UNITED STATES DEPARTMENT OF THE INTERIOR BUREAU OF LAND MANAGEMENT

Sundry Notices and Reports on Wells	∧PR	30 2010
1. Type of Well GAS	5. 5. 6. 6	Lease Number
2. Name of Operator	7.	Unit Agreement Name
BURLINGTON		
RESOURCES OIL & GAS COMPANY LP	0	Will Name C. Nimmber

PLUG AND ABANDONMENT PROCEDURE

Lodewick #8

Pronosed P&A

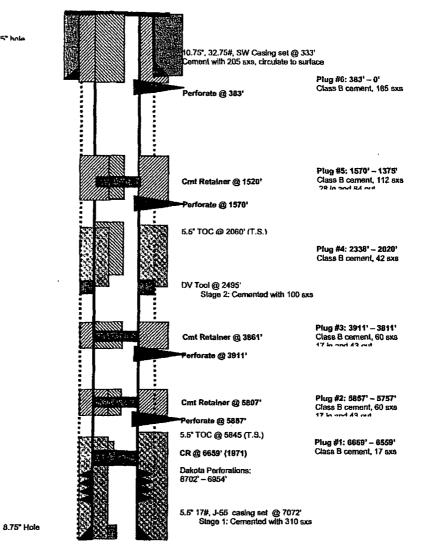
- 1. Plugging operations authorized are subject to the attached "General Requirements for Permanent Abandonment of Wells on Federal and Indian Lease."
- 2. Farmington Office is to be notified at least 24 hours before the plugging operations commence (505) 599-8907.
- 3. The following modifications to your plugging program are to be made:
- a) Place the Pictured Cliffs/Fruitland plug from 2338' 1933'.
- b) Place the Kirtland/Ojo Alamo plug from 1570' 1303' inside and outside the 5 ½" casing.

You are also required to place cement excesses per 4.2 and 4.4 of the attached General Requirements.
